Millstone 2, RAI 3

Draft of Information (DOI) – This DOI is entirely preliminary and used solely to support teleconferencing to affirm a common understanding of the scope and intent of several NRC questions. This DOI provides draft responses to the requests for additional information and, accordingly, the information provided should not be used as part of any NRC final decision making regarding this topic.

Millstone 2, Head Loss and Vortexing, RAI 6

Millstone 2, Chemical Effects Questions

Figure 1: Comparison of Debris Head Loss for Different Stations

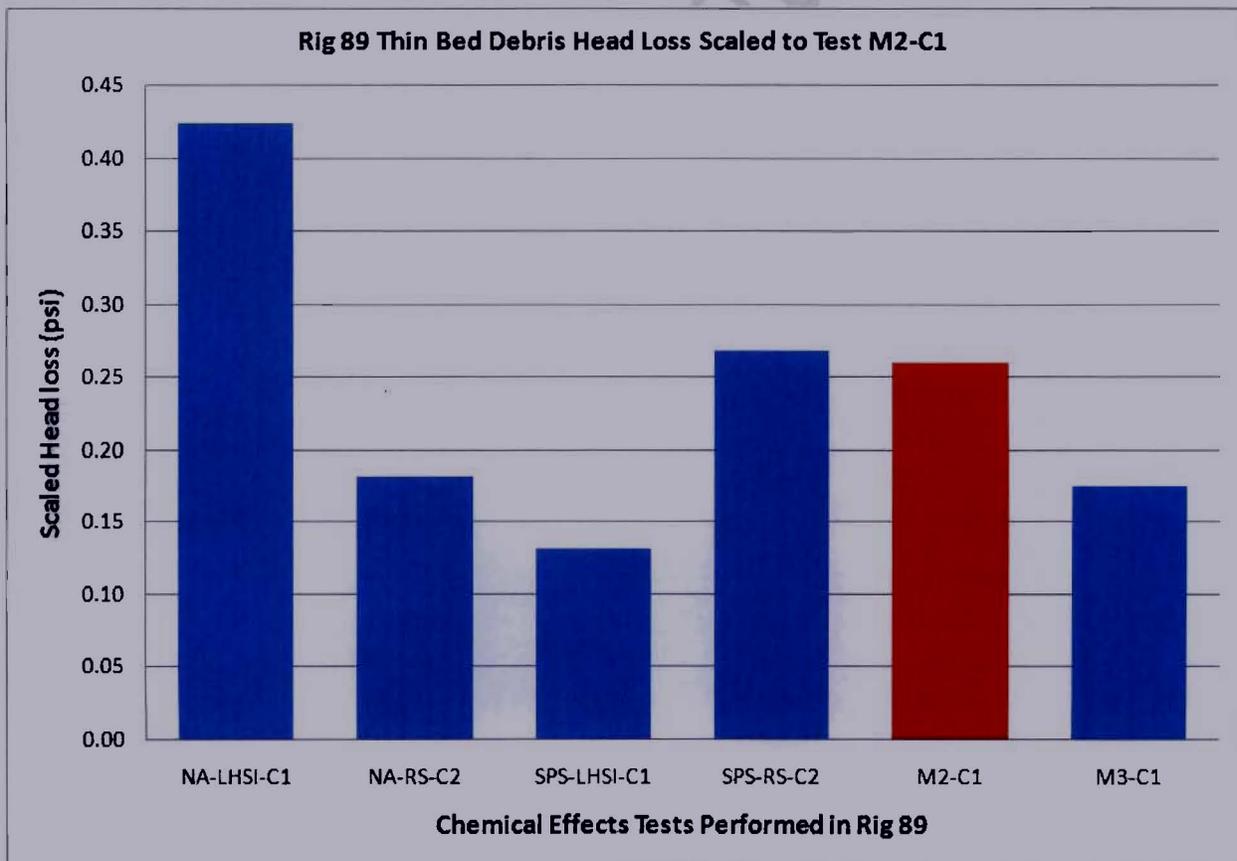
This RAI identified some differences in non-chemical head losses between the two test facilities. The December 18, 2008, DNC letter provided the first docketed information providing significant information on the MPS2 Rig-89 testing. The NRC staff has reviewed this and determined that the following information is needed to complete the review:

- a. Please provide information that justifies that the Rig-89 head loss test was conducted with a fibrous debris load that maximized non-chemical debris head loss.
- b. Please provide information regarding whether the debris bed contained adequate fiber to ensure that a maximum head loss was attained without bed disturbances limiting the head loss.

Since the Rig-89 test M2-C1 had only half the particulate debris amount in comparison with Rig 33 tests, the thin bed thickness of M2-C1 should not be higher than 1/8 inches. And so further fiber addition would only form a fluffy layer of fiber on top of the thin bed, which would not further increase the head loss. In order to verify this statement, all six chemical effects tests performed in Rig-89 for different strainers were compared. The peak thin bed head losses from different tests were scaled linearly based on approach velocity and quantity of particulate per unit area to match the approach velocity and particulate quantity of Millstone 2 test M2-C1, i.e., scaled head loss from Test x = (actual head loss from test x) × (M2 approach velocity / Test x approach velocity) × ((M2 particulate/area) / (test x particulate/area)). Note that the approach velocities for all other tests were higher than Millstone 2, and so scaling those head losses linearly to a lower approach velocity is conservative. The scaled head losses are plotted in Figure 1.

It can be seen that the head loss for test M2-C1 is very comparable to the other tests although M2-C1 was the only test that had 2 fiber additions of 1/16 inches theoretical bed thickness, while all other tests had 4 fiber additions. Therefore, it can be concluded that the Test M2-C1 had maximized the non-chemical head loss and further addition of fiber would not increase the head loss.

Figure 7: Dissolved Calcium Concentration in Equilibrium with Hydroxyapatite at pH

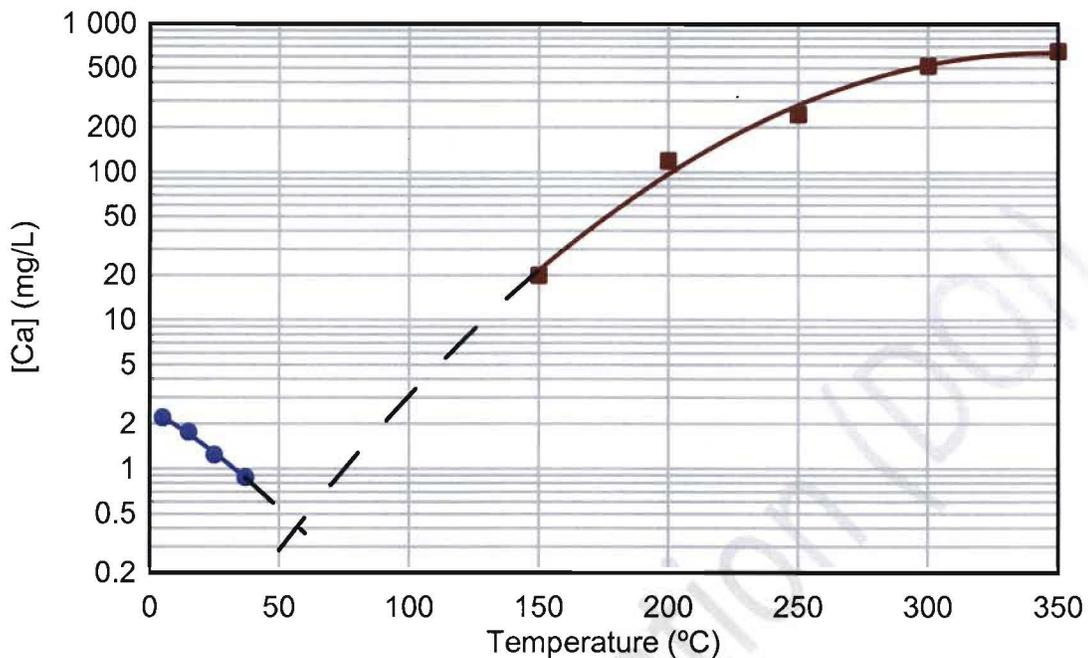
14. DNC's testing was performed at 104°F, which is well below early post-loss-of-coolant accident pool temperatures. The solubility of calcium phosphate (hydroxyapatite) decreases as the temperature increases. Please discuss whether more calcium phosphate precipitate would have formed in the Rig-89 tests if this test would have been performed at higher temperature. If more calcium phosphate precipitate would be expected at a higher temperature, when the short-term NPSH margin is applicable, please justify why the overall Rig-89 test results provide for an adequate evaluation of chemical effects.

For the first hour following a LOCA, when temperatures may approach 212°F (100°C) and calcium release from the various sources should not exceed 3 mg/L², the solubility from Figure 7 is predicted to be about 3.5 mg/L and therefore calcium phosphate is not expected to precipitate.

If Rig 89 tests were performed at higher temperature, e.g., at an early post-LOCA temperature such as 100°C or a longer-term temperature such as 65°C, the available data (Figure 7) suggest that the solubility should be greater and there should be less precipitation. Furthermore, the results of the test show that the solution is stable with respect to precipitation at concentrations greatly exceeding the calculated solubility, likely as a result of kinetic factors. Thus, the Rig 89 tests provide an adequate evaluation of chemical effects and therefore show that worst-case head loss remains within available NPSH margin.

Figure 13: Comparison of AECL/WCAP Aluminum Release Models' Predictions of Submerged, Sprayed and Total (Combined) Aluminum Release for Millstone 2 Post-LOCA

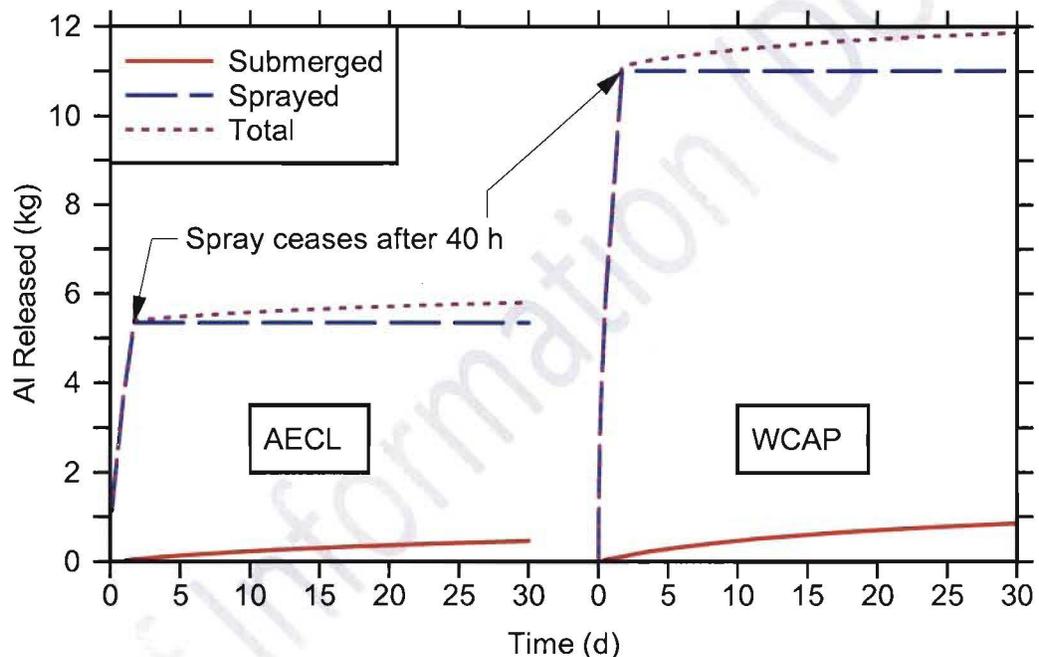
15. Please compare the total amount of aluminum that is predicted to be released by the AECL model with that predicted by the WCAP-16530 base model (i.e., no refinements for silicate or phosphate inhibition). Discuss any significant differences between the plant specific predictions for the two methods, including the acceptability of these differences.

The Millstone 2 post-LOCA sump and spray operates mainly in the range of pH 8.0-8.3, where the WCAP model predicts a greater aluminum release rate at high temperatures than the AECL model (Figure 11). For the 1876 ft² of sprayed and 24 ft² of submerged aluminum reported to be present at Millstone Unit 2 [3], the WCAP model predicts 11.9 kg Al whereas the AECL model predicts 5.8 kg Al (Figure 13). It should be noted that the scaled equivalent of 6.6 kg Al was added during the Rig 89 test⁴ and that the last 5 aluminum additions (Figure 14), representing over 60% of the aluminum added, did not produce increases in head loss, suggesting a head loss plateau.

Figure 16: Debris Bed Head Loss vs. Time for Test M3-

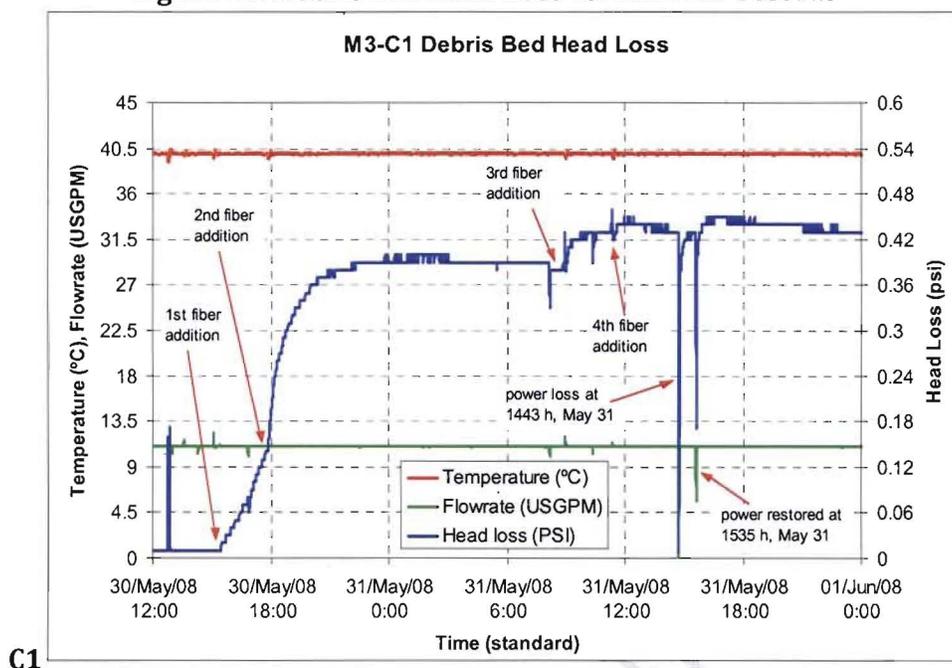
1. The December 18, 2008, DNC letter provides contradictory information on the amount of fibrous debris added during the test. On page 8, Attachment 2, it is stated that the limiting bed was determined to be 1/4 inch during earlier testing. Yet the same paragraph states that only two increments, containing fibrous debris to form 1/16 inch bed each, were added to the test and that no further fiber was added. Page 16 states that two 1/16 inch additions were made and implies that two further additions were made later. In addition, the graph on page 19 shows 4

fibrous additions. Describe, in detail, the initial fibrous debris conditions of the test and the amount of any additions that were made during the test.

2. *The December 18, 2008, DNC letter states that the limiting thin bed for MPS3 is 1/4 inch as determined by previous testing. However, the head loss plot on page 19, Attachment 2, indicates that the third and fourth 1/16 inch fiber additions had little effect on head loss. Please evaluate the thin bed thickness for MPS3 in consideration of these points. Also, if the thin bed for the Rig-89 test is different from that of other tests that were used to provide Rig-89 test inputs, please provide an evaluation of how the final qualification test could have been affected by the use of such inputs. The licensee's assertion that 55% of the debris attached to the strainer for the Rig-89 test, and 72% and 84% attached to the strainer for the reduced scale test should also be considered in this evaluation.*

For the Millstone 3 Rig-89 chemical effects test M3-C1, four fibrous debris additions were made to the test loop to achieve a thin bed thickness of $\frac{1}{4}$ inch as determined by previous thin bed tests. The first fiber addition (1/16 in. (1.6 mm)) was made at 1504 h, May 30, 2008, after the addition of the particulate debris. The second fiber addition (an additional 1/16 in. (1.6 mm)) was made at 1750 h, May 30, 2008. The third and the fourth fiber additions (each 1/16 in.) were made at 0856 h and 1120 h, May 31, 2008, respectively. The detailed debris addition information is also indicated in the head loss vs. time curve as shown in Figure 16.

As shown in Figure 16 (response to RAI 6 issue 1), the debris bed head loss increased from 0.38 psi to 0.43 psi after the third fiber addition, indicating that the thin bed thickness was at least equivalent to three additions. After the fourth fiber addition, the head loss peaked at 0.45 psi and stabilized at 0.43 psi before the first chemical addition. This indicates that the fourth addition made little difference and the thin bed could be considered to be less than ¼-inch.

Figure 17: Ottawa River Water Level High and Peak Millstone 3 Rig 33 Test Head

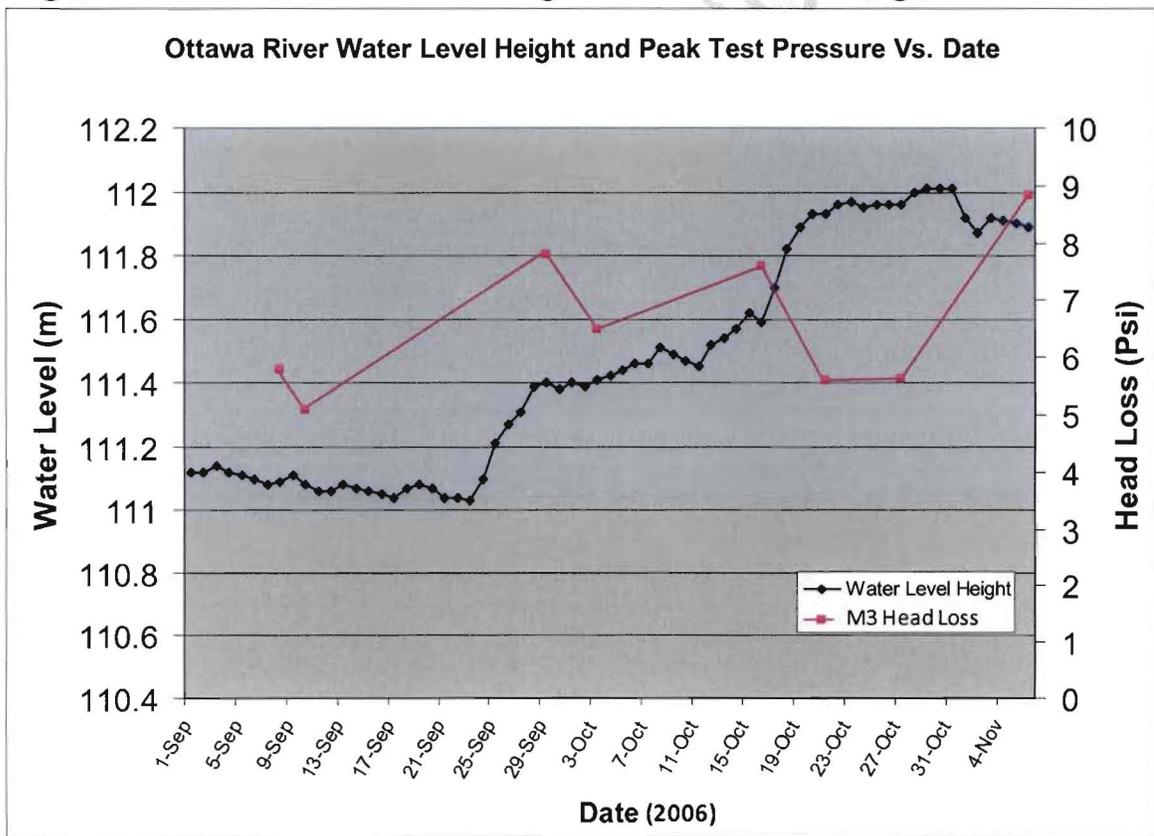
- a. *Provide an evaluation of the degree to which the particulate and biological growth from the river water affected the results of MPS3. It appears that the MPS3 tests were affected to a much greater degree than other AECL tests conducted under similar conditions. Please discuss the reason MPS3 was affected to a greater degree.*

The water level height of the Ottawa River could also affect the concentration of river particles and slime forming organisms. Higher water level resulted in higher peak head loss as shown in Figure 17.

Figure 18: Theoretical Air Evolution at a Point on the Strainer Submerged by 26

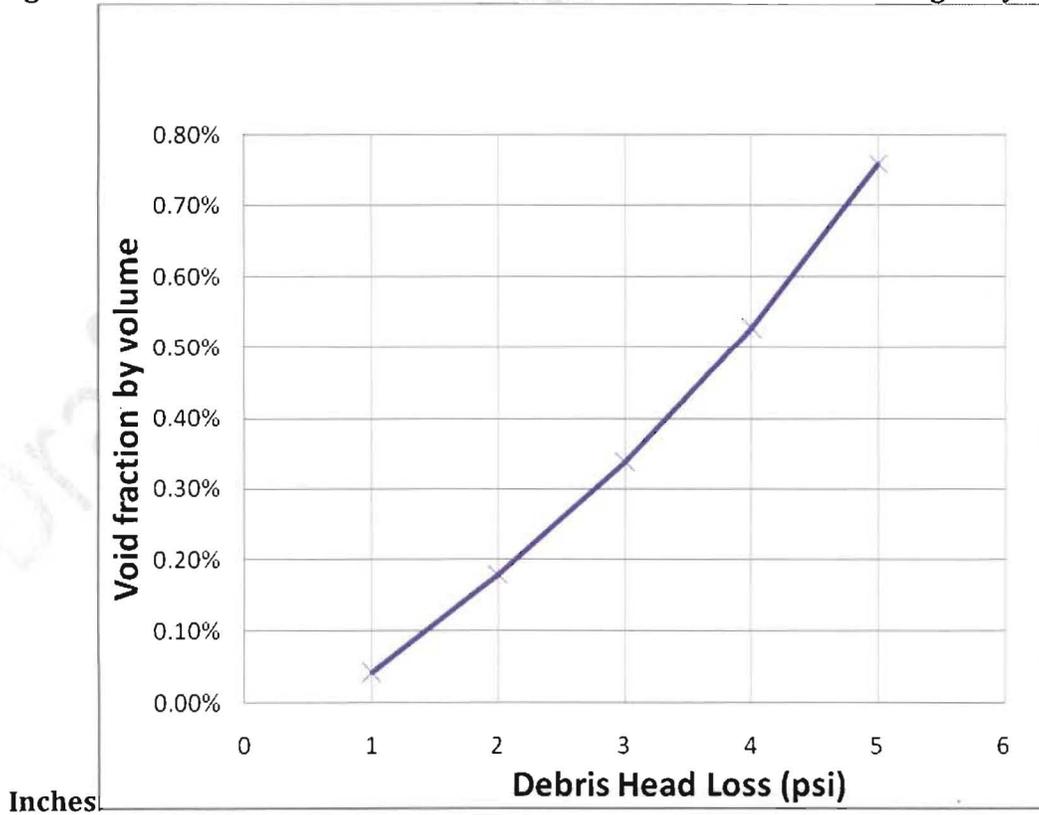
4. *Please provide additional details on how the postulated air evolution affected the MPS3 head loss tests considering the following:*
 - a. *Please provide an evaluation of how the air evolution phenomenon affected the MPS3 tests compared to other AECL tests conducted under similar conditions. Please provide information on why air evolution, as a factor in head losses, would only occur for AECL strainers.*

Based on a dissolved air calculation, it was found that air evolution increases significantly as the head loss across the debris bed increases. Figure 18 shows a theoretical plot of how air evolution is affected by debris head. This plot assumes that air will evolve out of solution immediately it exceeds the saturation concentration, whereas it is likely that there is some time delay and the actual air release would be less than indicated. Nevertheless, for a relatively small head loss, air evolution is very low and it starts to become more significant as head loss exceeds approximately 2 psi. The tests performed for

Figure 21: Head Losses vs. Debris Addition in Millstone 3 Large-Scale Thin Bed

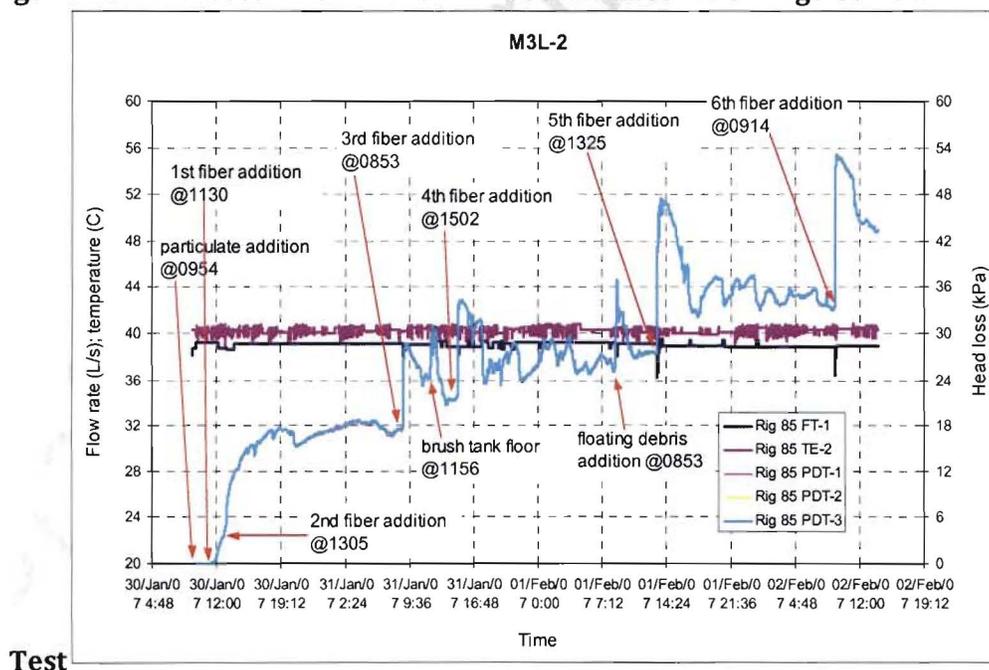
- b. *The response to RAI 4 stated that the air evolution began to affect head loss as soon as the fibrous debris was added to the test and that the head loss began to decrease as soon as fibrous debris additions were stopped. Please provide an evaluation of why the*

air evolution would begin to affect head loss as fiber was added to the test and why it would stop as soon as fibrous debris additions were stopped.

- c. Please provide an evaluation of why the evolution of air, caused by the addition of fibrous debris with air entrained in it, would result in the highest head loss when a relatively small amount of fibrous debris was added.*

During the test, the head loss stabilized at 2.7 psi after the second fiber addition. The third fiber addition increased the head loss to 4.1 psi. Three more fiber additions were added into the test and each addition caused a spike in head loss as shown in Figure 21. DNC's response to RAI 4, dated March 13, 2009, referred to the fourth, fifth and six fiber additions. Prior to these fiber additions, air evolution had already reached a significant level due to high debris bed head loss.

The observed head loss spike after the fourth, fifth and sixth fiber addition was due to the air bubbles trapped inside the fibrous debris. Microscopic examination of fibers prepared in a similar fashion (i.e., using a pressure washer to agitate and break up the clumps of fiber) showed that air bubbles were attached to the fibers (see Figure 22). It was the air bubbles that initiated the pressure spikes, not the fibers.

As soon as the fibers reached the debris bed, the bubbles started to migrate into the debris bed, blocking flow area and causing the head loss to increase. The increasing head loss caused the generation of more bubbles within the bed, which, in turn, caused a further increase in head loss. Once a debris addition was completed and no new bubbles were arriving at the debris bed, then the continuing migration of air bubbles through the debris bed into the fins begin to decrease, unblocking flow area and causing further head loss decreases. Eventually, the rate of air generation decreased to become equal to the rate of air migration, and the head loss stabilized at a lower value than the peak value.
